City of Portland, Maine – Building or Use Permit Application 389 Congress Street, 04101, Tel: (207) 874-8703, FAX: 874-8716

Location of Construction: 349 Park Ave		Owner: H.P. Hood, Co., Inc.		Phone: 774-9861		Permit No. 9 81237	
Owner Address: SAA 04102		Lessee/Buyer's Name:		Phone:		Business Name:	
Contractor Name: Centerline Construction		Address: P.O. Box 1264 Portland, ME 04102		Phone: 865-3300		Permit Issued: OCT 29 1998	
Past Use: Commercial Office Space		Proposed Use: Same		COST OF WORK: \$ 10,605.00		PERMIT FEE: \$ 75.00	
				FIRE DEPT. <input type="checkbox"/> Approved <input type="checkbox"/> Denied		INSPECTION: Use Group: Type:	
				Signature:		Signature:	
Proposed Project Description: Rehab conference room				PEDESTRIAN ACTIVITIES DISTRICT (P.A.D.) Action: Approved <input type="checkbox"/> Approved with Conditions: <input type="checkbox"/> Denied: <input type="checkbox"/>		Zoning Approval: Special Zone or Reviews: <input type="checkbox"/> Shoreland <input type="checkbox"/> Wetland <input type="checkbox"/> Flood Zone <input type="checkbox"/> Subdivision <input type="checkbox"/> Site Plan maj <input type="checkbox"/> minor <input type="checkbox"/> mm <input type="checkb

CONF. ROOM

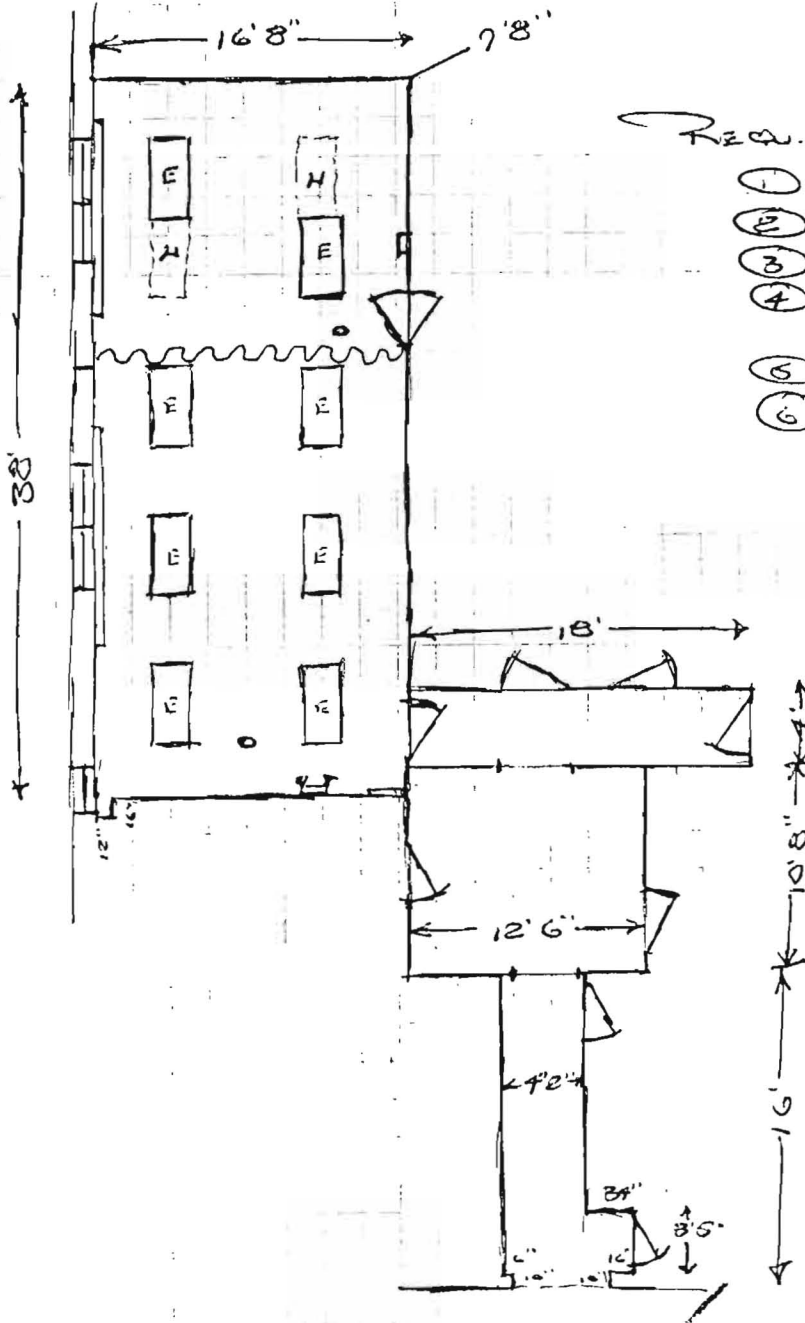
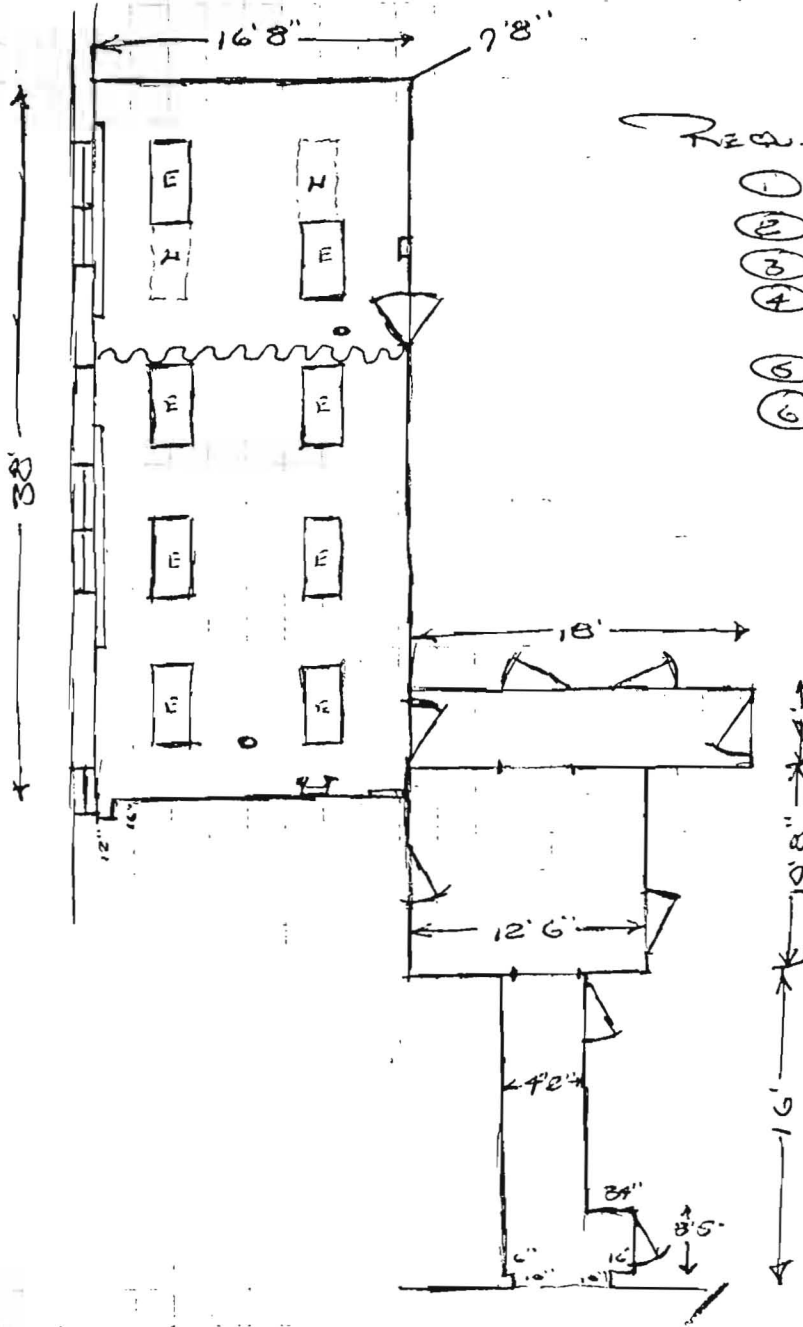
30. Glass and glazing shall meet the requirements of Chapter 24 of the building code.
- X-31. The proposed interior door (accordion) shall be installed as per
The manufactures requirements.
